Final Drainage Report
for
Rolling Hills Ranch Filing 3
at
Meridian Ranch

EL PASO COUNTY, COLORADO

March 2021

SF-21-016

Figure 2: FEMA Floodplain Map

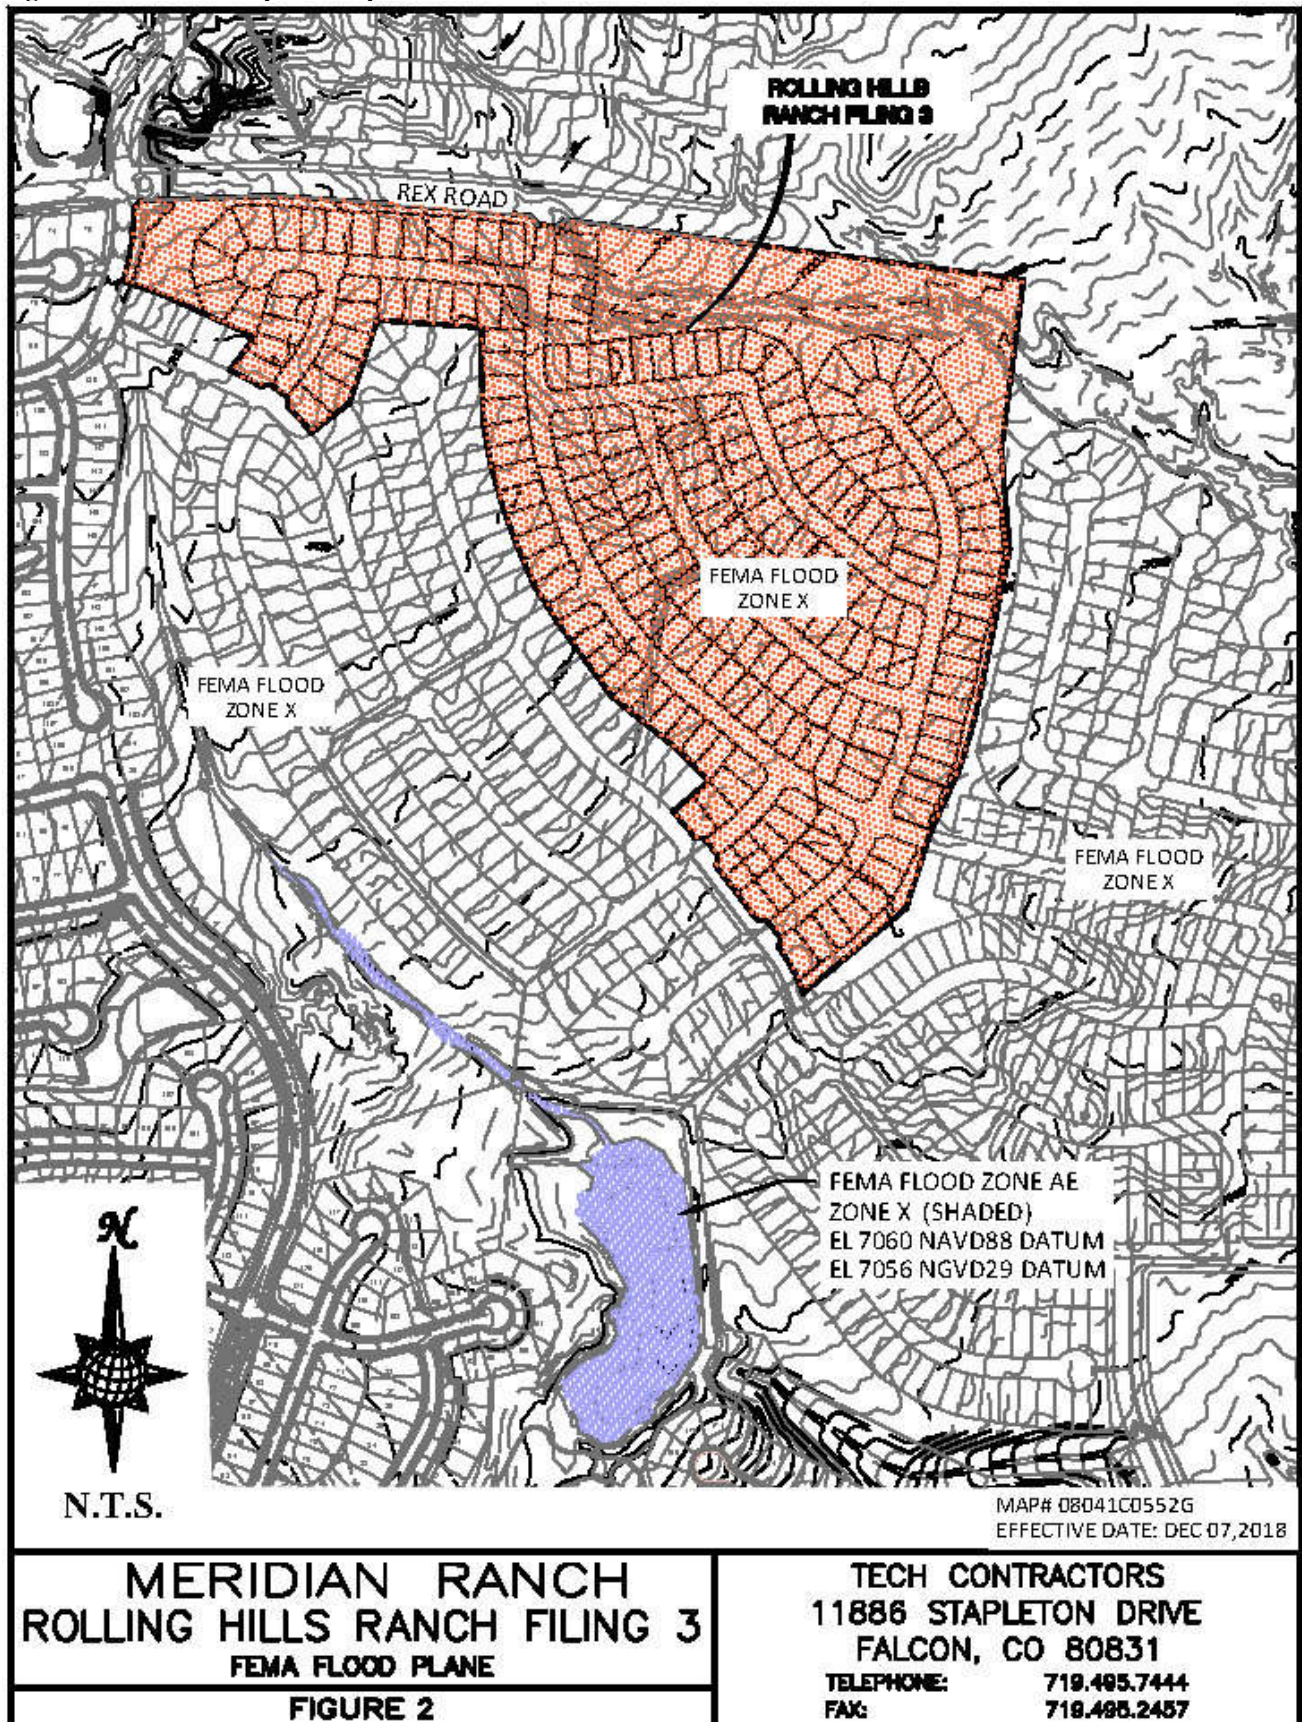
Update statement.
No portion of Filing 3
is within a designated
floodplain per the
exhibit provided.

Notate that this is not
within Filing No 3

~~The designated floodplain is located within a drainage open space identified as Tract C. The floodplain is identified as a Zone AE with an elevation of 7060 based on the NAVD88 Datum. The topography is based on the NGVD29 Datum, therefore an adjustment to the base flood elevation shown in the map is required. The net result is a base flood elevation of 7056 for this location.~~

REMOVED THIS
PARAGRAPH
